LIGONIER DAM

NDI No. PA 00477
PennDER No. 65-117

PHASE I INSPECTION REPORT
NATIONAL DAM INSPECTION PROGRAM

Ligonier Dam, Westmoreland County, Pennsylvania
NDI No. PA 00477, PennDER No. 65-117
South Fork of Mill Creek
Inspected 11 December 1979

LIGONIER DAM
TOP OF DAM PROFILE
TYPICAL CROSS-SECTION

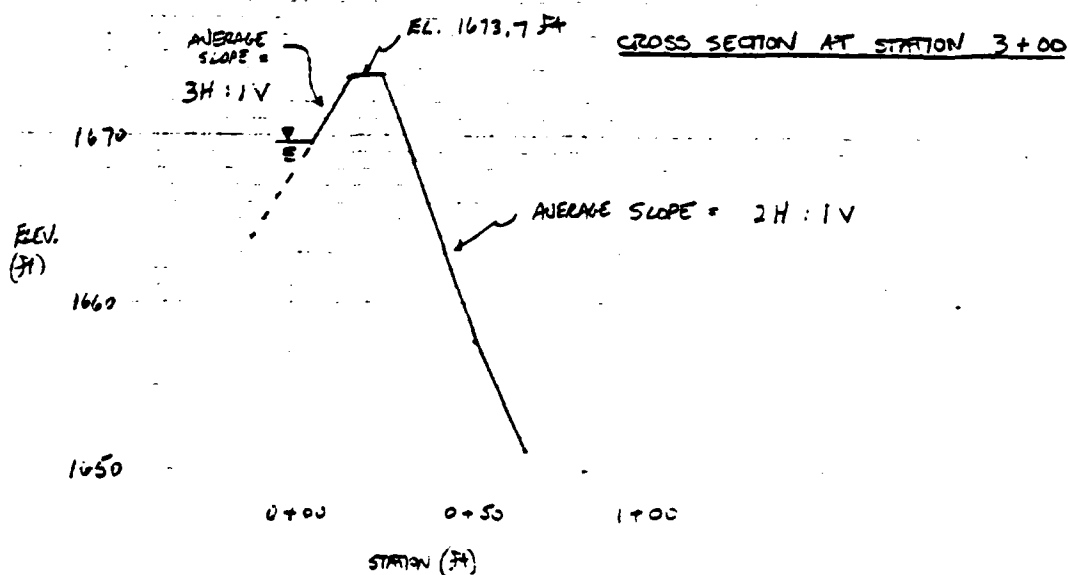
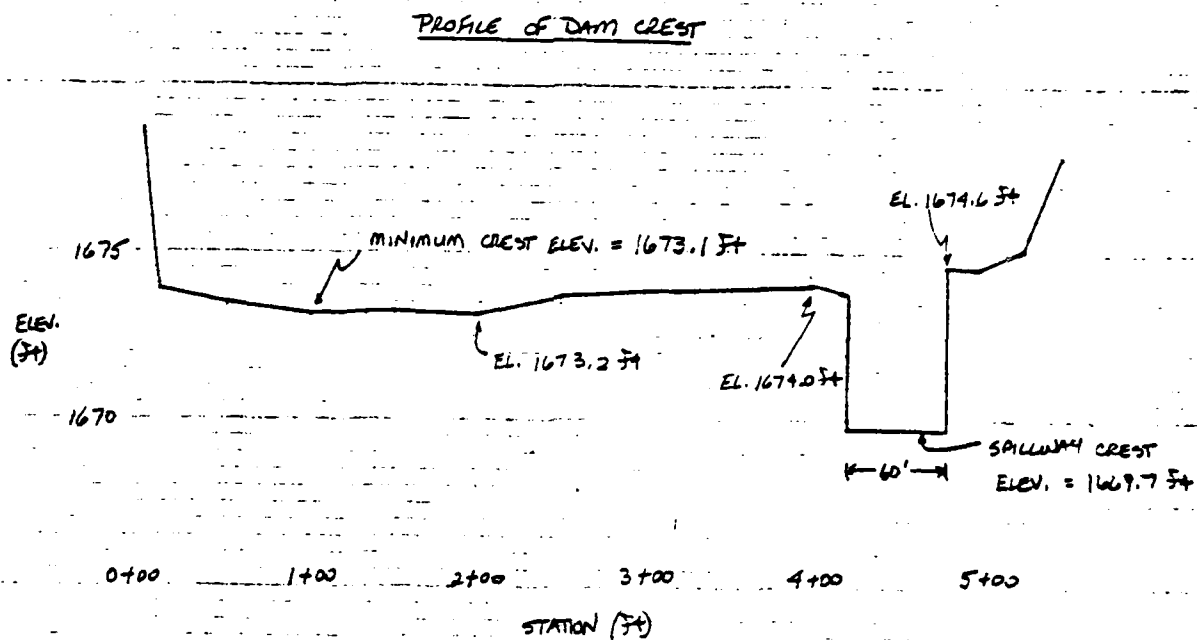
- 3) The crest of the embankment was low (see top of dam profile at the end of Appendix A). The top of dam should be raised to design elevation of 1674.5 feet M.S.L.

- 3) It is recommended that the dam be raised to the original design elevation of 1674.5 feet M.S.L.
- 4) The seepage area previously noted should continue to be examined in the future and the condition recorded. Should future inspections disclose that the quantity or encroachment on the downstream face has increased and/or turbidity is observed in the seepage, then further evaluations and corrective measures may become necessary to protect the structural stability of the embankment.
